**CITY OF FIRCREST
PLANNING COMMISSION
MEETING AGENDA**

**TUESDAY, NOVEMBER 04, 2025
6:00 P.M.**

At the October 7, 2025 Planning Commission meeting, I presented proposed revisions to the Fircrest Municipal Code (FMC) which intended to implement HB 1293 (design review) and HB 1337 (accessory dwelling units, “ADUs”). In my initial review of the FMC, I noted discrepancies with the following statutory provisions of the Growth Management Act adopted by HBs 1293 and 1337:

Parking lots

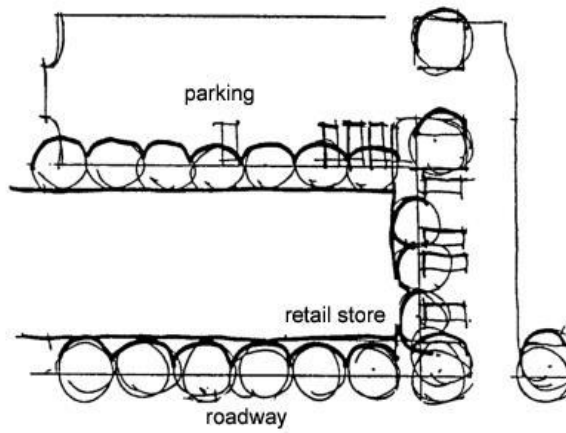
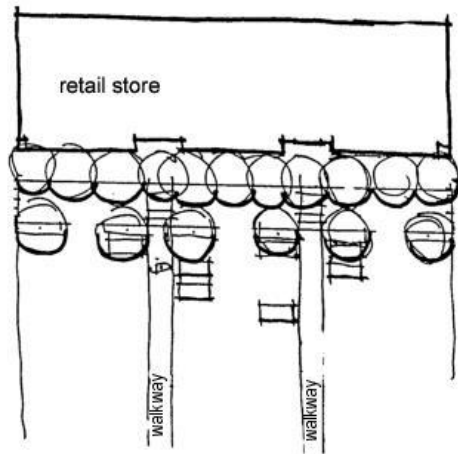
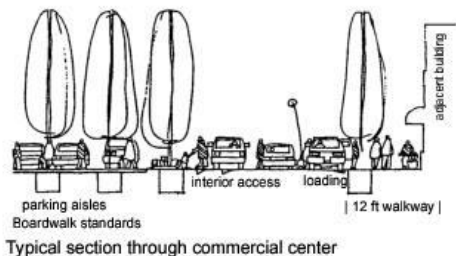
Commented [KM1]: “Large” cuts and “tall or long” walls are subjective. After reading Ord. 1272 which created this language, it is not clear what was attempted to be avoided through codifying this provision. Based on the Intent statement in this section, it seems that long walls and large cut/fill were viewed as “unsightly” or otherwise not in keeping with a natural landscape. Edits to this effect have been made for Planning Commission’s contemplation at its November 4 meeting.

Modulation

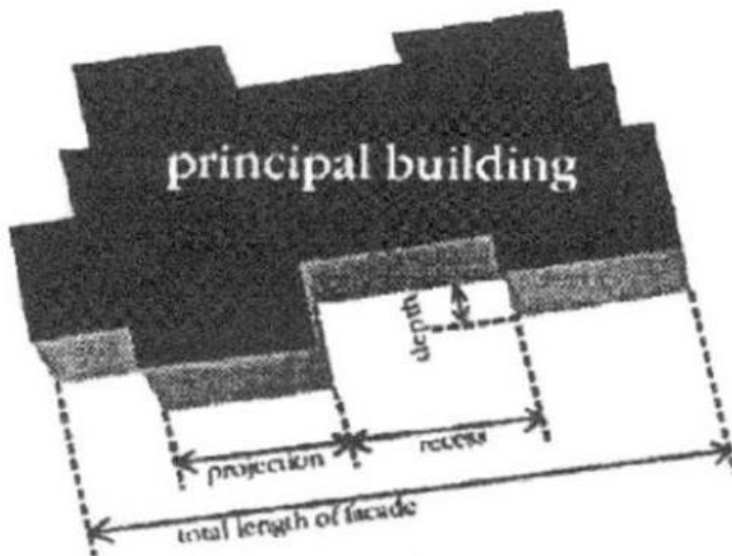
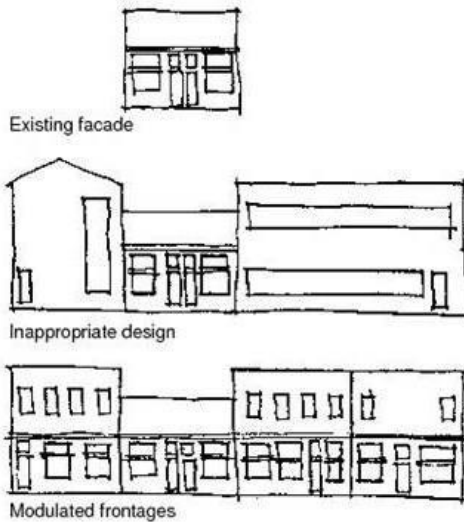
Commented [KM3]: Reflects feedback from October 7 Planning Commission meeting.

(c) ~~Modulation and articulation should be used in a clear rhythm to reduce the perceived size of all large buildings.~~^{Repealed.}

22.64.020 Shopfronts.

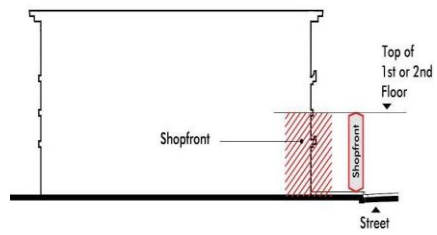
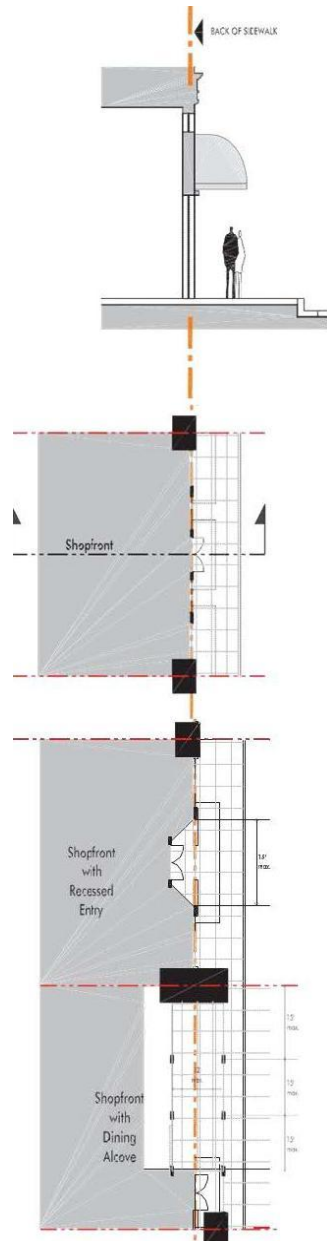
Commented [KM11]: I am recommending this edit to add specificity to the intention here.

Commented [KM12]: If we're saying "at least 10 feet" we should remove "to 14" to avoid confusion.
